**From:** Joe Barra <Joe.Barra@pgn.com>  
**Sent:** Tuesday, September 15, 2015 7:49 AM  
**To:** Siegel, Scot  
**Subject:** Sensitive Lands

**From:** Siegel, Scot  
**Sent:** Tuesday, September 15, 2015 6:44 PM  
**To:** Joe Barra  
**Subject:** RE: Sensitive Lands  
**Attachments:** 634 Carrera Lane correct RP buffer 09-15-15.pdf

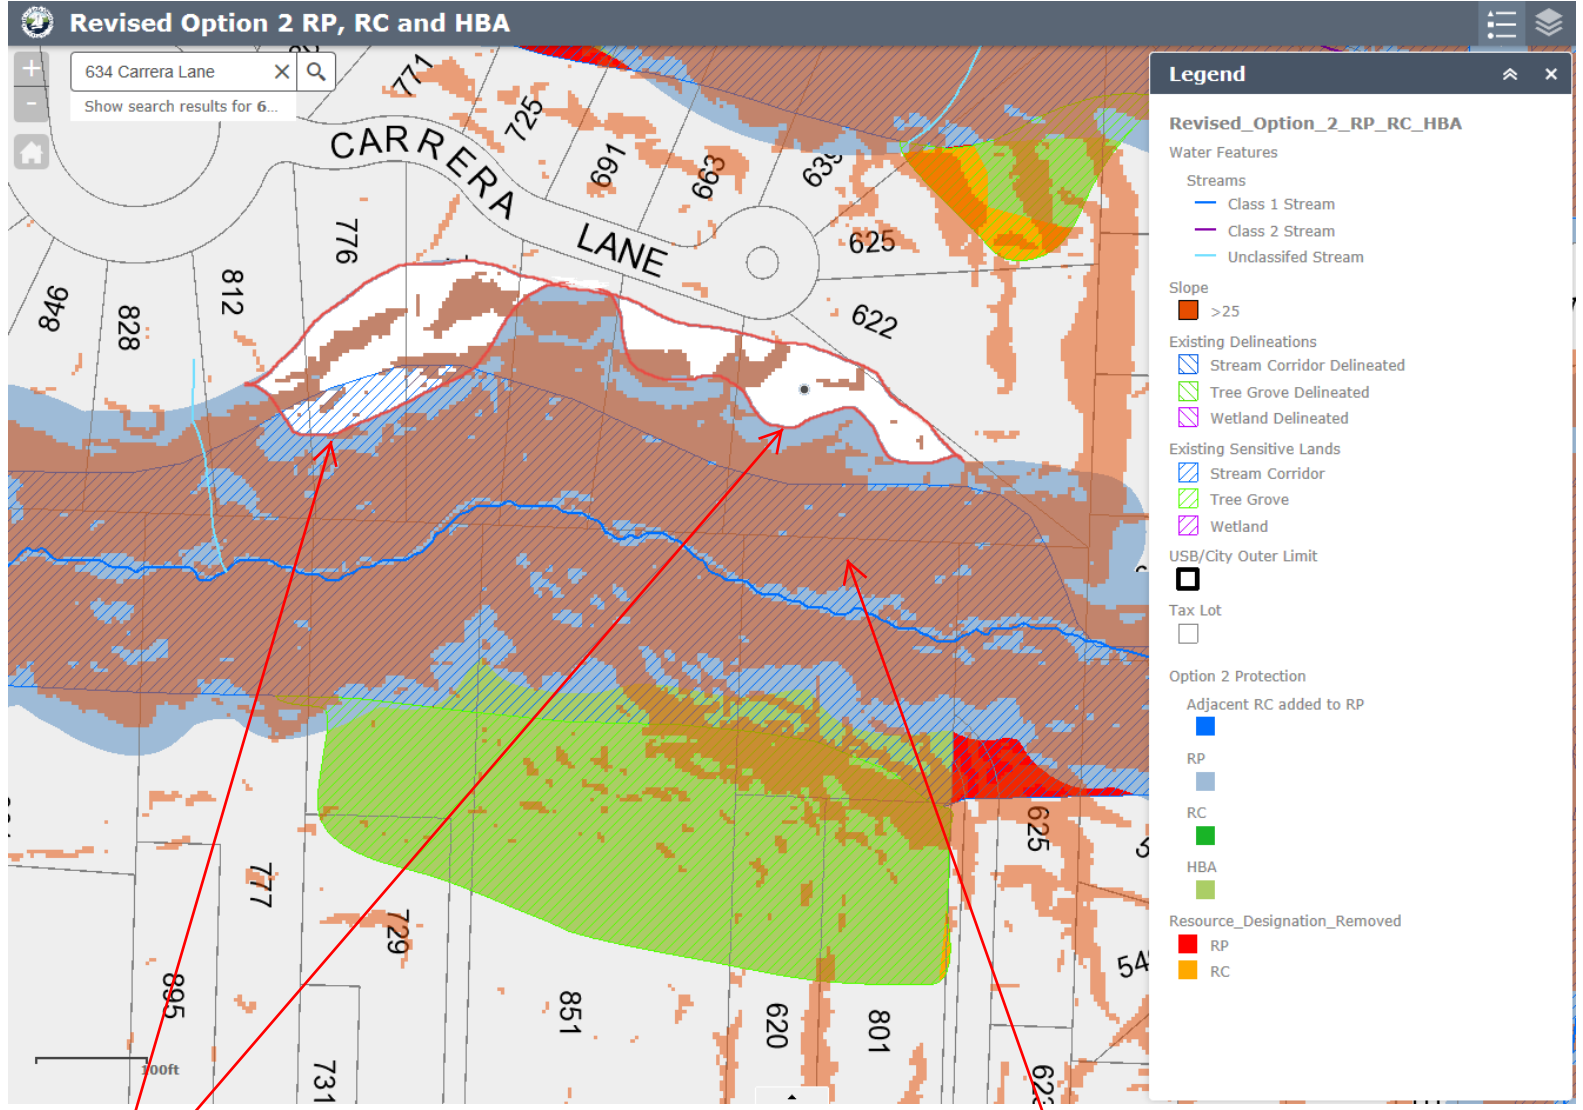
Edit RP buffer to better conform to top of bank (consistent break in 25% slope).  
 Remove excess area (white inside red lines).

Current RP mapping (shown as blue cross-hatch pattern) does not accurately reflect stream corridor with buffer.

I have attached a revised version of the same map that shows the extent of the slope or ravine (orange area) with suggested corrections (shown in red outlines), which I believe better reflects the topography in your area. The 30 foot buffer is represented as the blue fringe just outside the orange slope area. Please let me know if this makes sense. I am also glad to discuss it by phone or in person.
